PROJECT	Brickline Greenway North Connector – Phase 3	ADDENDUM NUMBER	01
PROJECT NO.	14654 (GRG 308s)	DATE	9/1/2026
PROJECT LOCATION	St Louis, Missouri		
CLIENT	Great Rivers Greenway		
PREPARED BY	Hannah Higgins, SmithGroup

ADDENDUM #01

Proposed changes include the following updates and the related pay item, bid tab, and JSP adjustments required:

- Updated sidewalk/landscape layout north of Lindell Ave.
- Updated Electrical sheets.
- Updated Soil, Landscape, and Irrigation sheets
- Updated Trail signage sheets

SUMMARY OF QUANTITIES

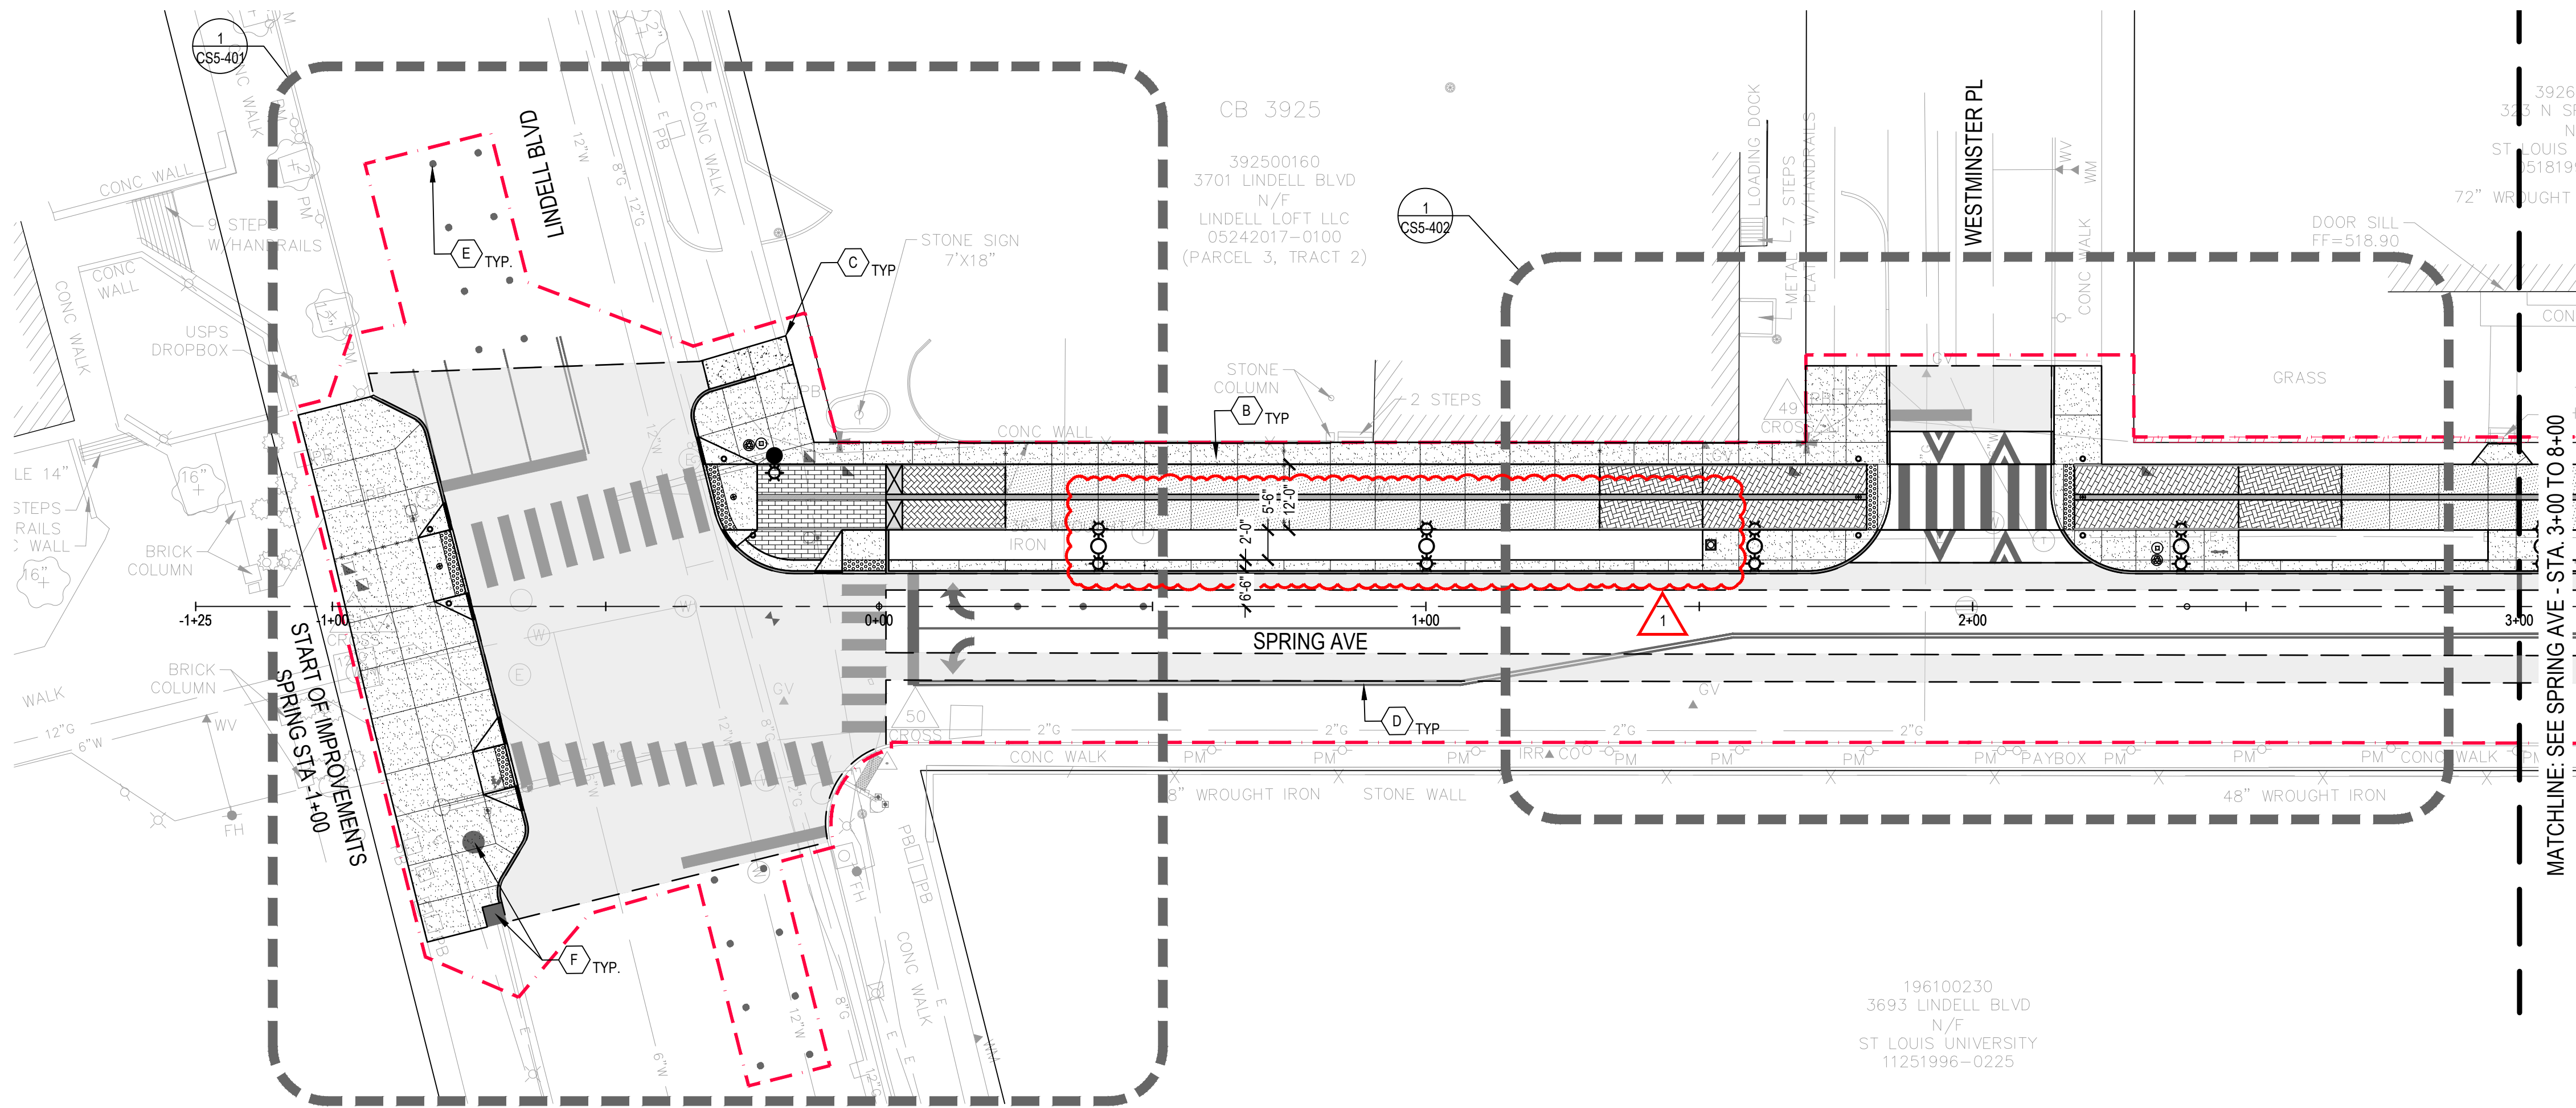
- A. G2-001 SUMMARY OF QUANTITIES - Updated to reflect adjusted quantities and new pay items identified in this document.
- B. CS5-101 LAYOUT AND MATERIALS PLAN – SPRING – AREA 1: Sidewalk limits updated between Lindell and Westminster.

LIGHTING PLAN

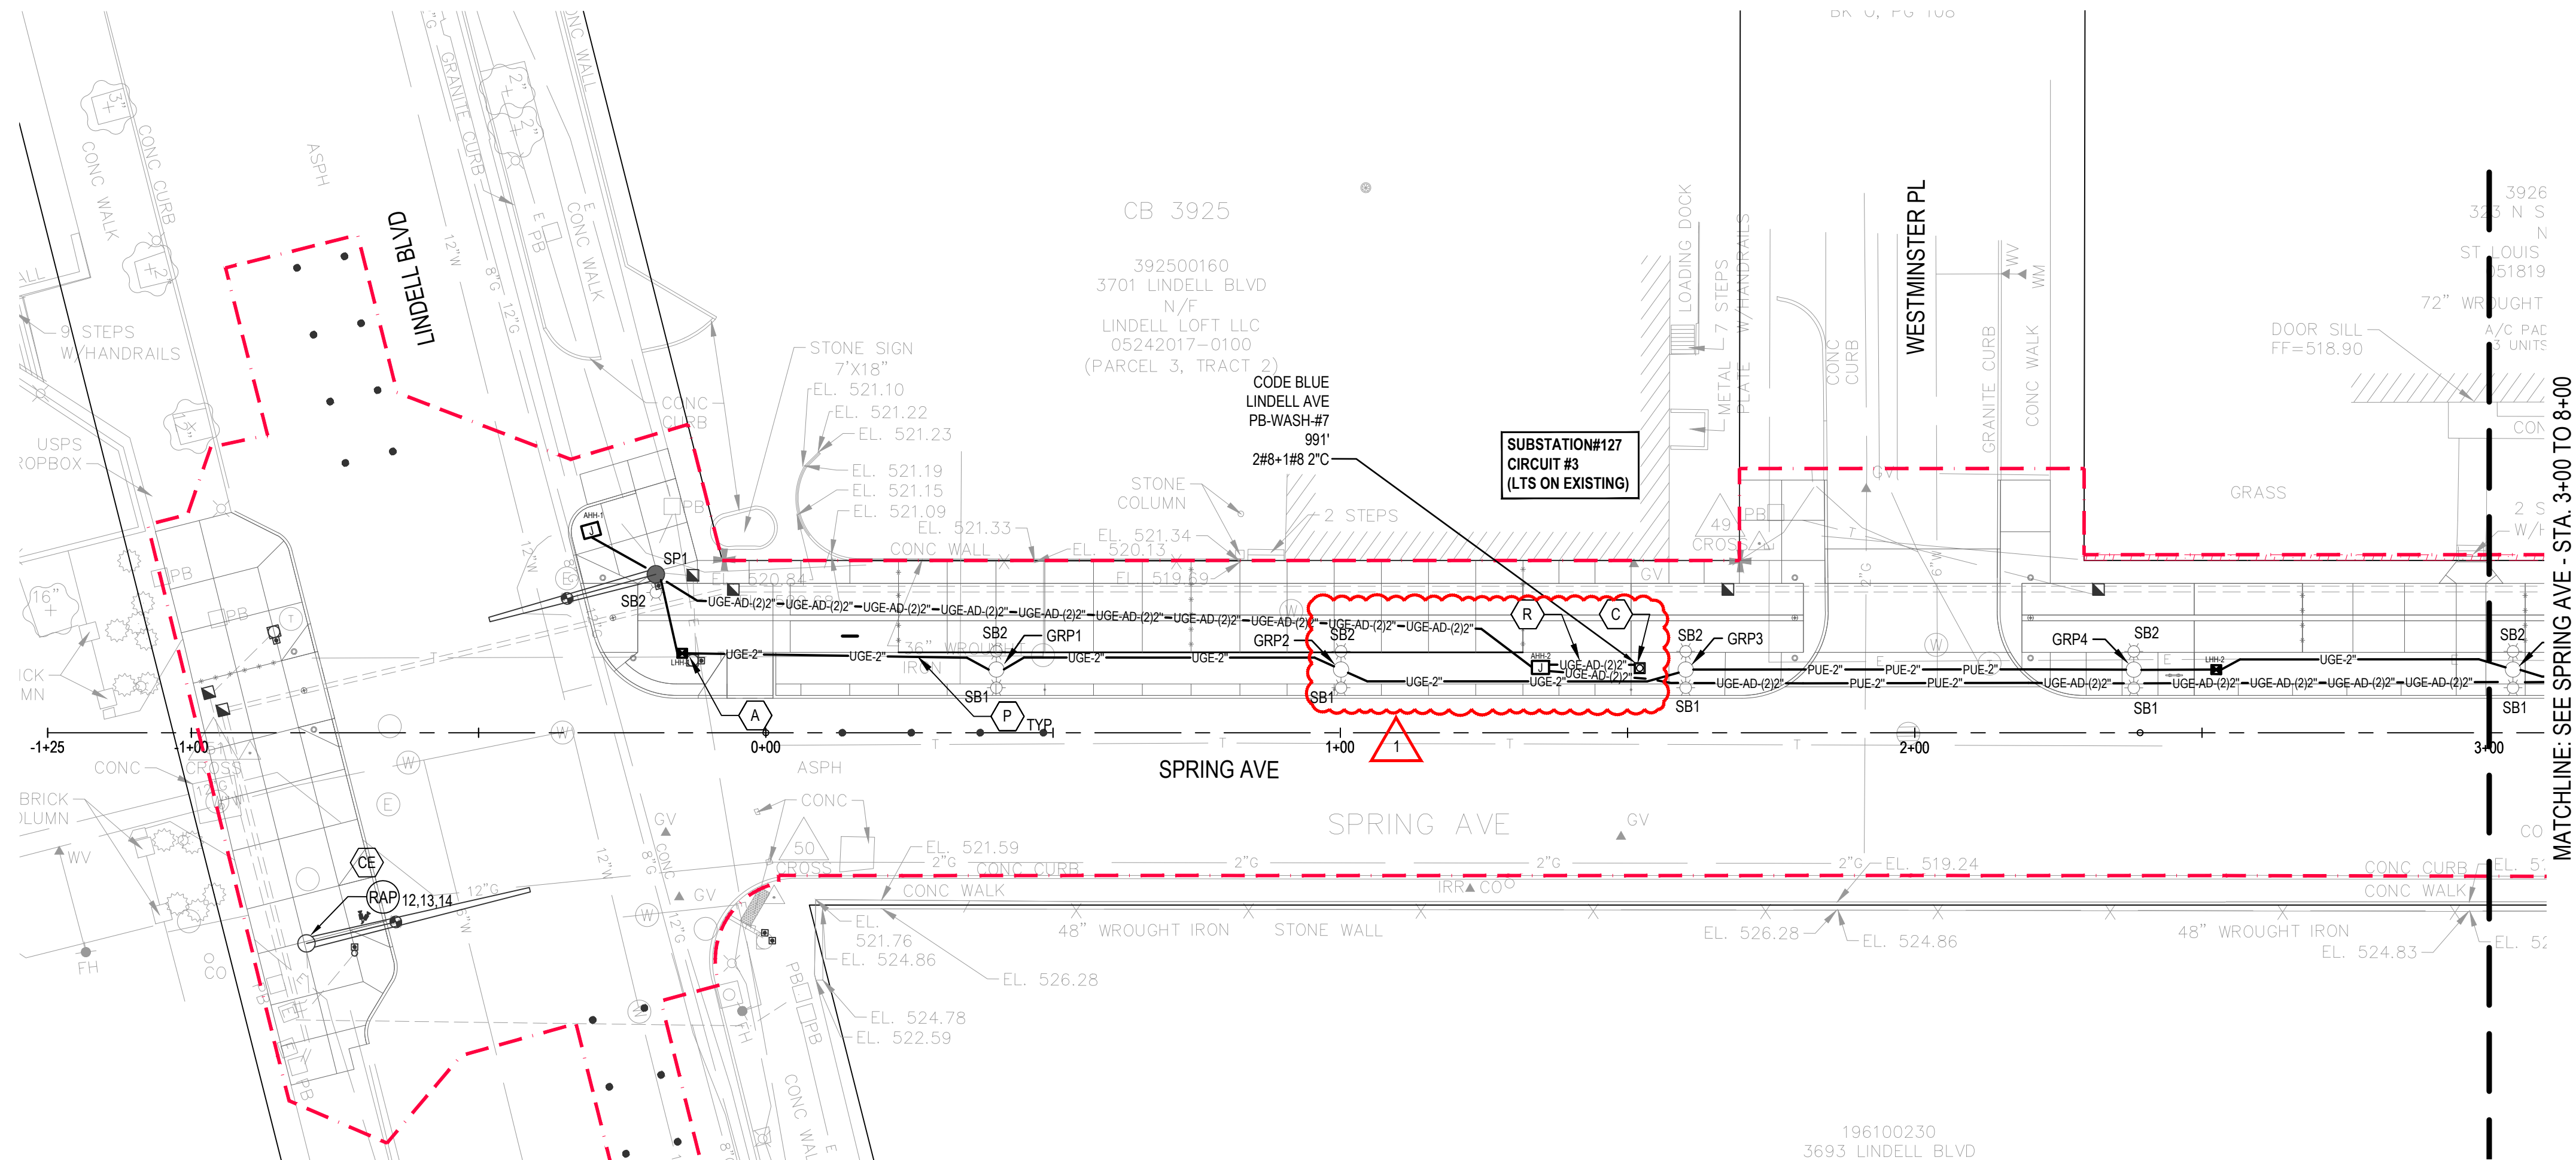
- E. E1-101 ELECTRICAL PLAN – SPRING – AREA 1: Adjusted AHH-2 location to reflect new Code Blue station location. Revised conduit routing to route to new AHH-2 location and feed new Code Blue station.

LIGHTING PLANS

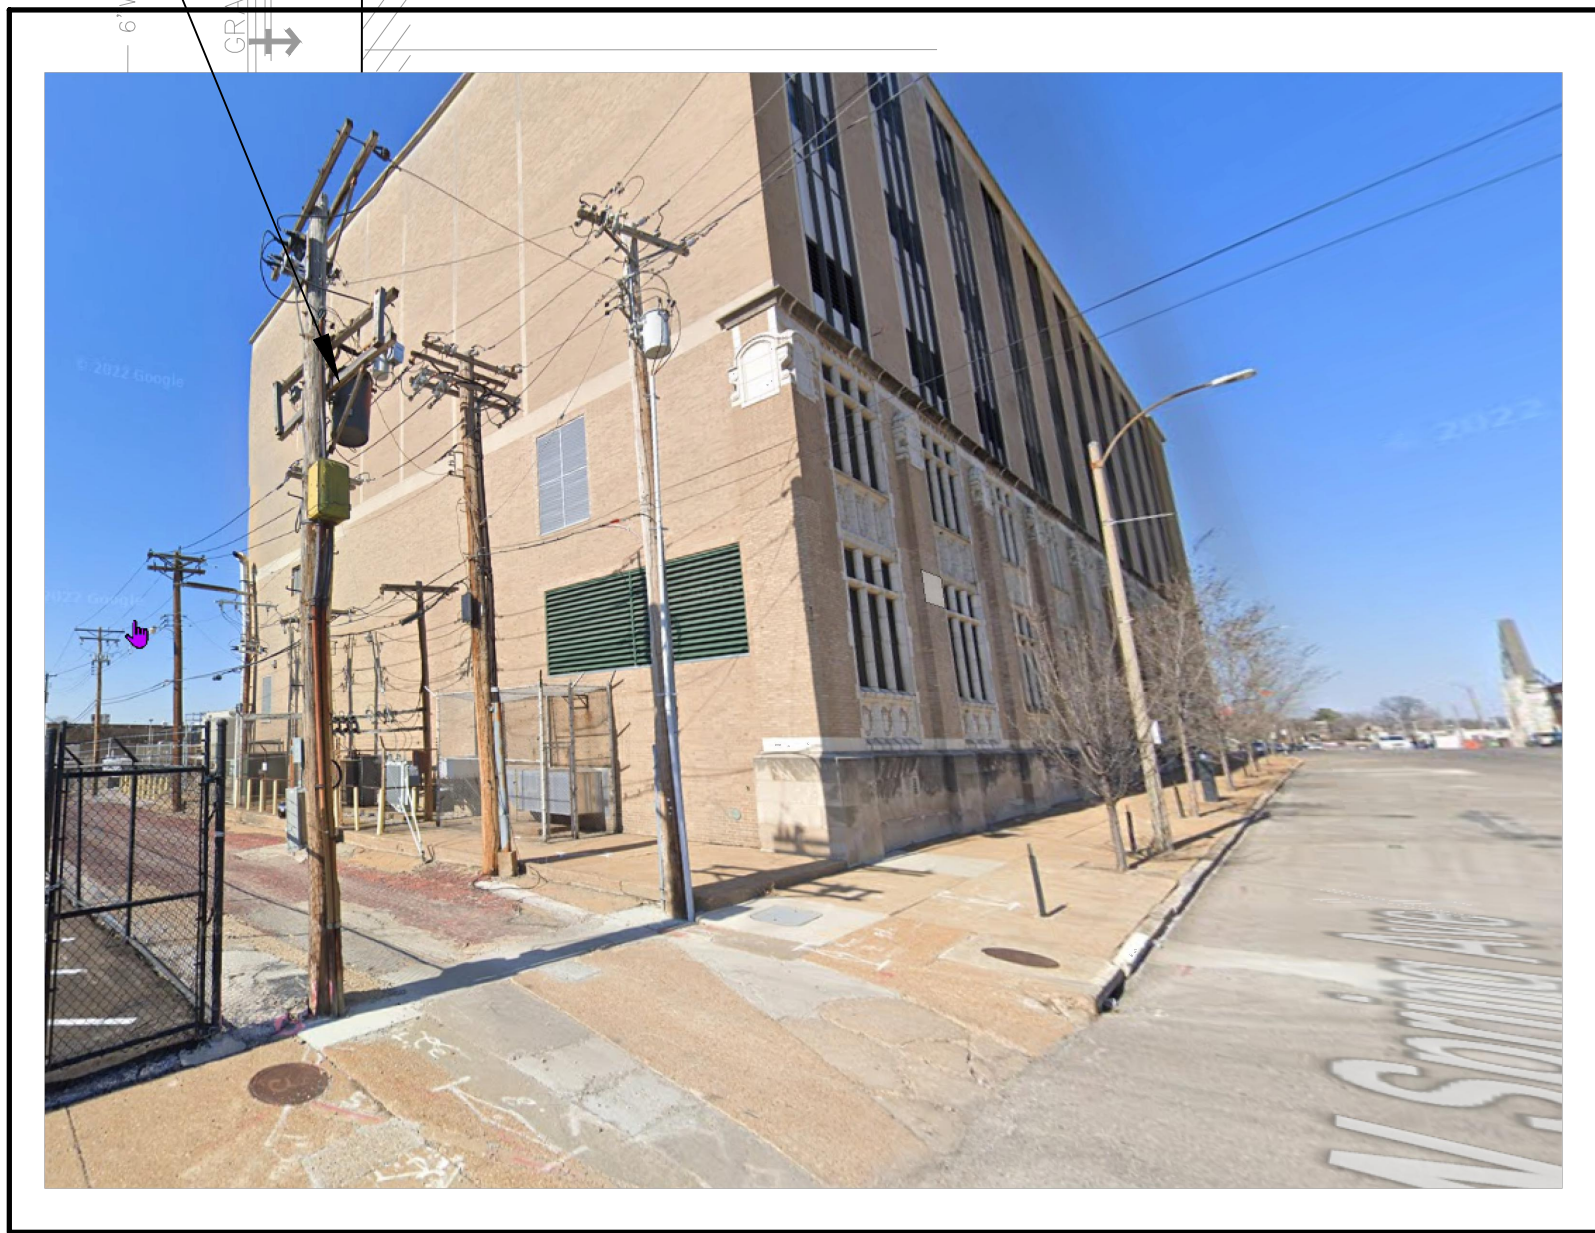
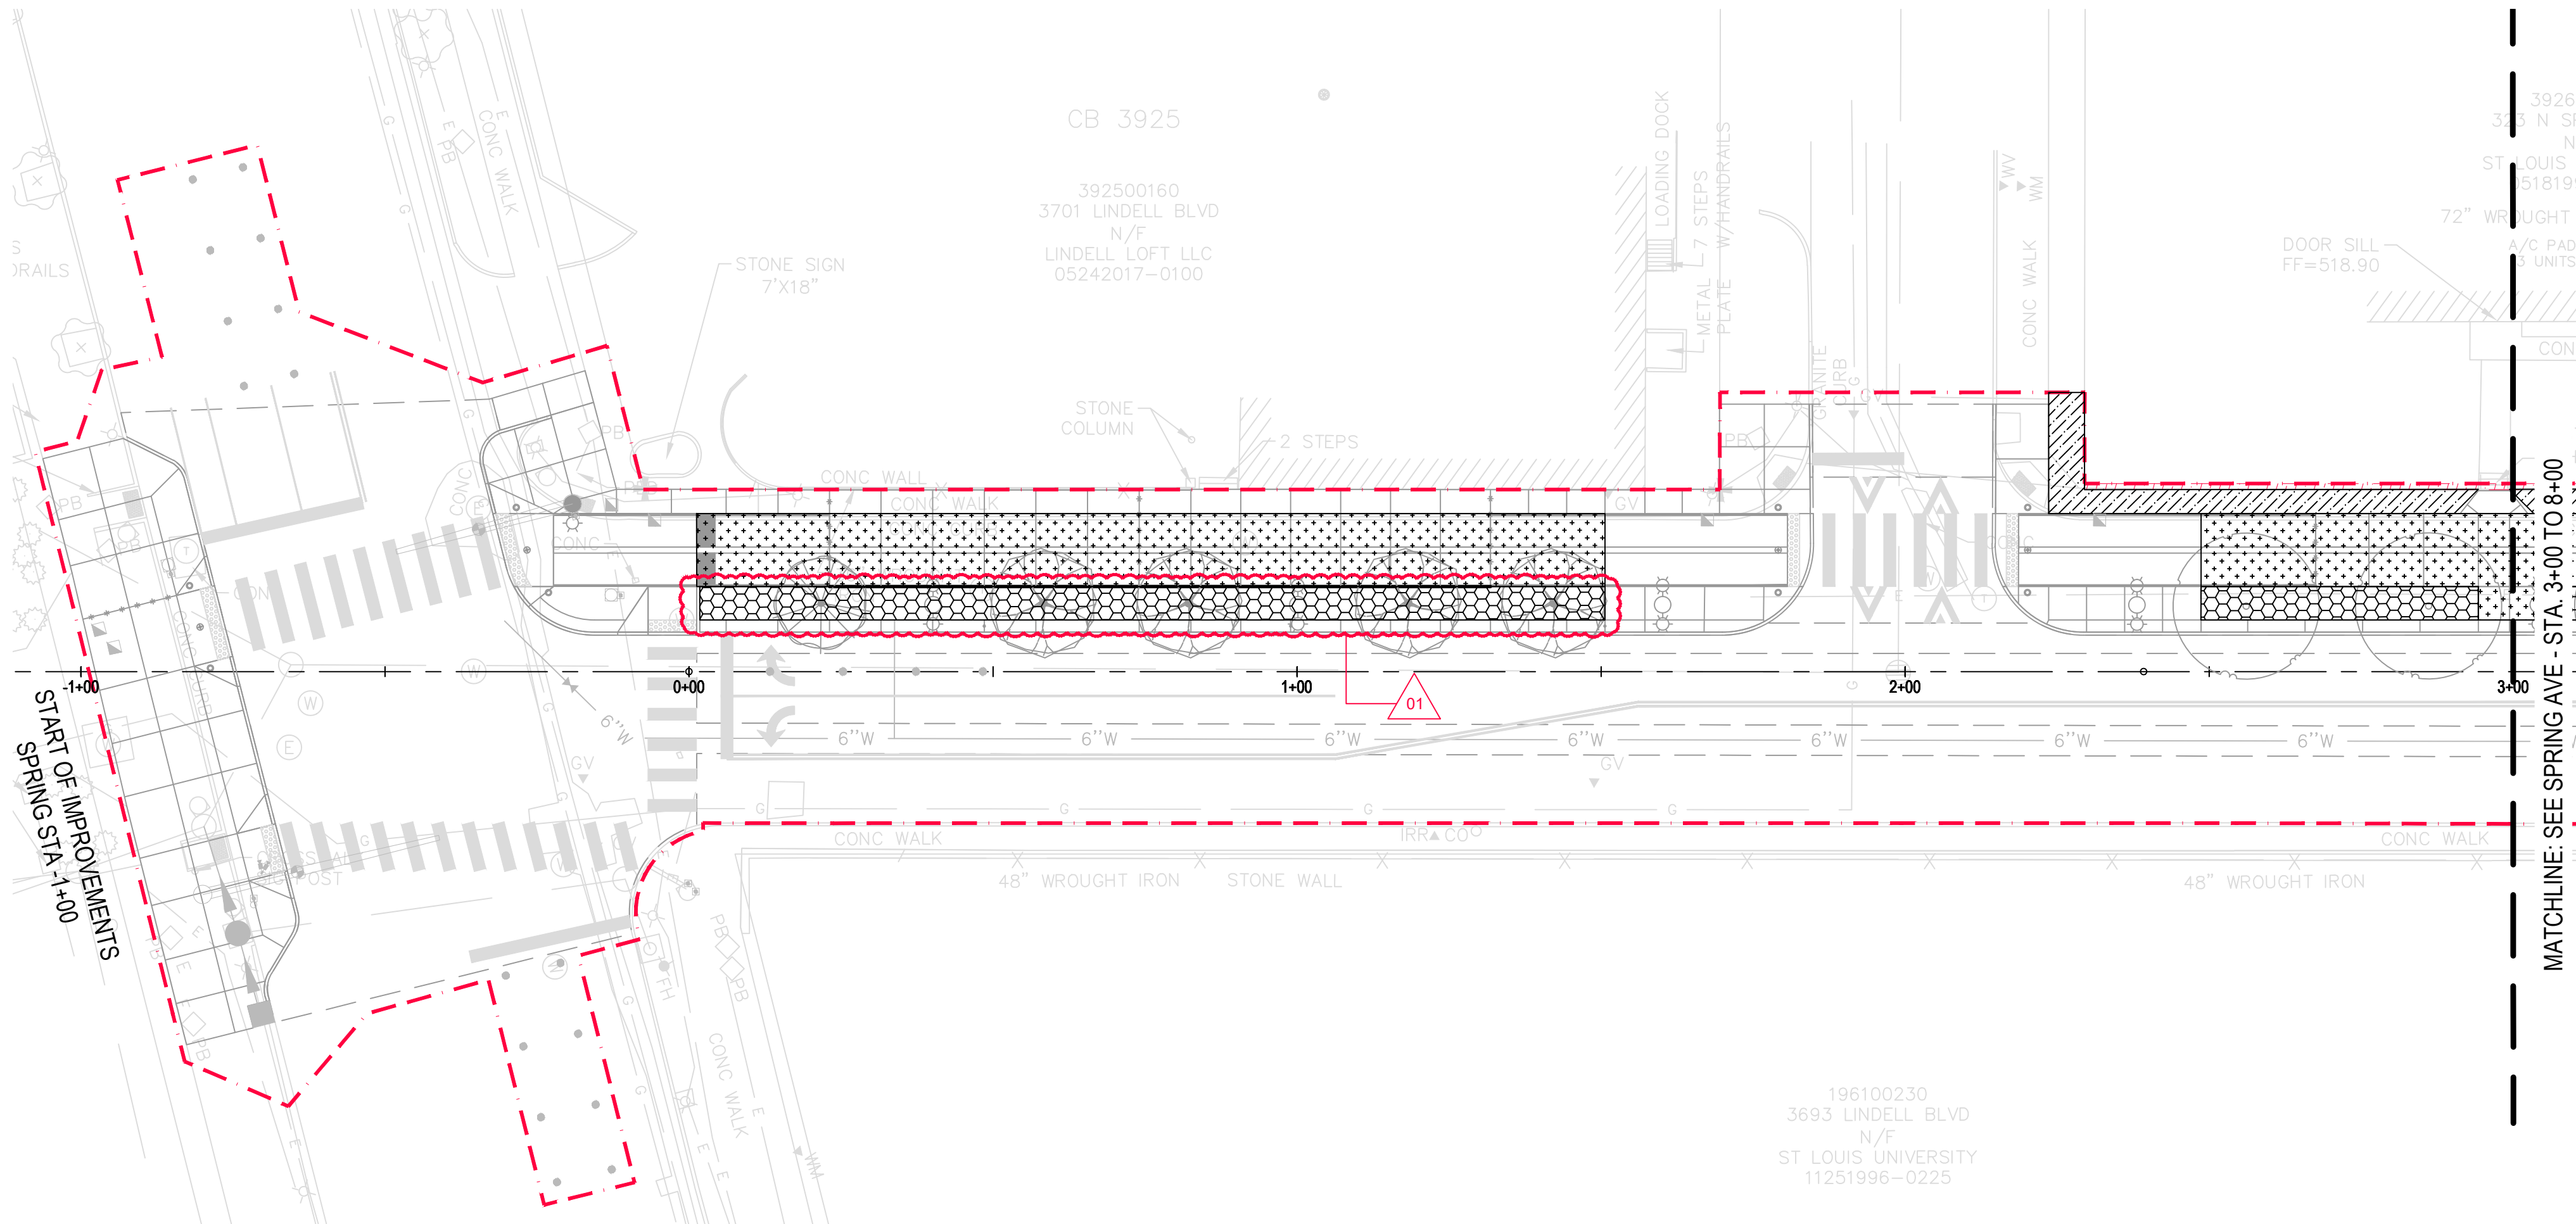
- F. E1-103 ELECTRICAL PLAN – SPRING – AREA 3: Added (3) receptacles to existing festoon light poles and added conduit routing to them. Added new Ameren substation location and new keynote. Revised Ameren conduit to route from new substation to PB-WASH meter. Added conduit from existing Substation #127 to LHH-6 and from LHH-6 to new handhole LHH-7 across Washington Ave. Added conduit from LHH-7 to SB2 to power lights on existing Substation #127 circuit.

SOIL PLAN - SPRING - AREA 1

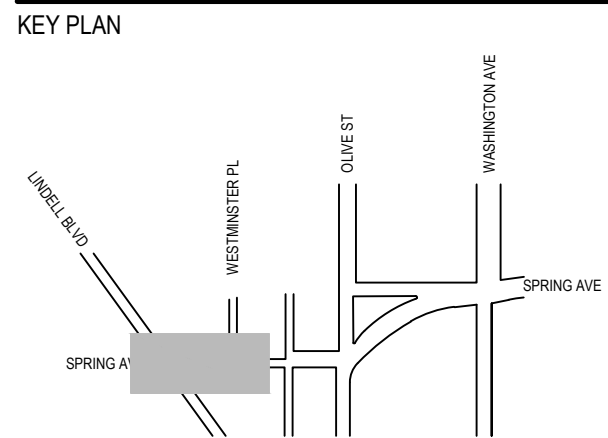
- H. L1-101 SOILS PLAN - SPRING - AREA 1: Updated planting soil extents
- I. L2-101 LANDSCAPE PLAN - SPRING - AREA 1: Updated plant schedule quantities to correct count discrepancies and to accommodate reduction in pavement and expansion of planting beds.
